# UNITED STATES PATENT AND TRADEMARK OFFICE

APPLICATION NO.	FILING DATE	FIRST NAMED INVENTOR	ATTORNEY DOCKET NO.	CONFIRMATION NO.
09/467,293	12/17/1999	ROSS S. TSUGITA	247/062	2206

# Office Action Summary

## DETAILED ACTION

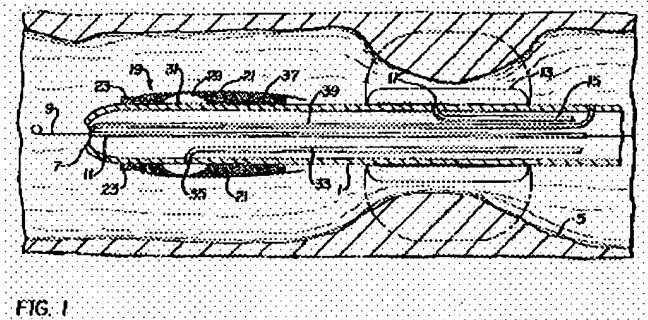
In figures 2-4, Miller, et al., demonstrates the conventionality of embodiments where the filter is introduced via lumen and is deployed past the distal end of the cannula.

Moreover, enhancing figures 2-4, with an expandable or occluder is another conventional design in the art as evidenced by the teachings of Wholey, et al.

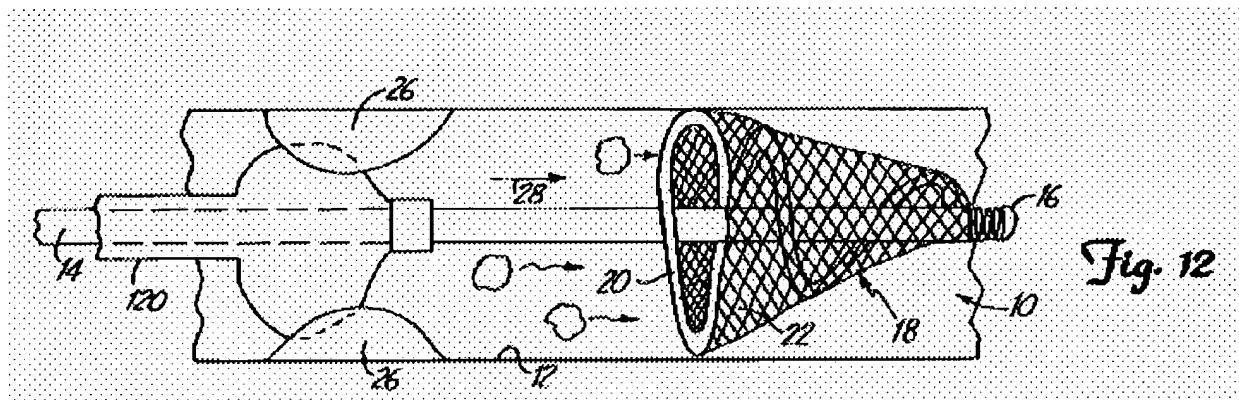
**Claims 19 and 23-28** are rejected under 35 U.S.C. 103(a) as being unpatentable over **USSR 764684, in view of Daniel, et al., and/or Kerr**. USSR 764684 shows in figures 5 and 6, the insertion of the distal end of a catheter/cannula apparatus into an aorta, the catheter/cannula system having a filter that is deployable upon introduction into the heart. The cited foreign patent does not disclose an occluder in the outer wall

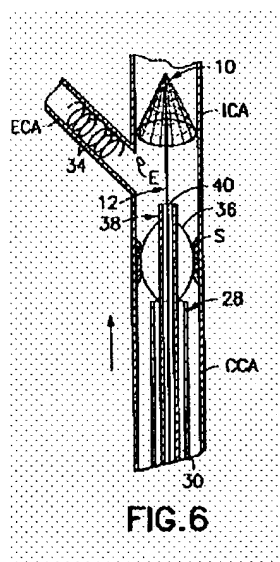
In figure 12, Daniel, et al., shows an occluder in the outer wall of the catheter and a lumen-deployable filter. Additionally, in figures 6 and 13 below, Kerr also demonstrates the conventionality of using an occluder in the outer wall of the catheter and a lumen-deployable filter in a catheter cannula apparatus.
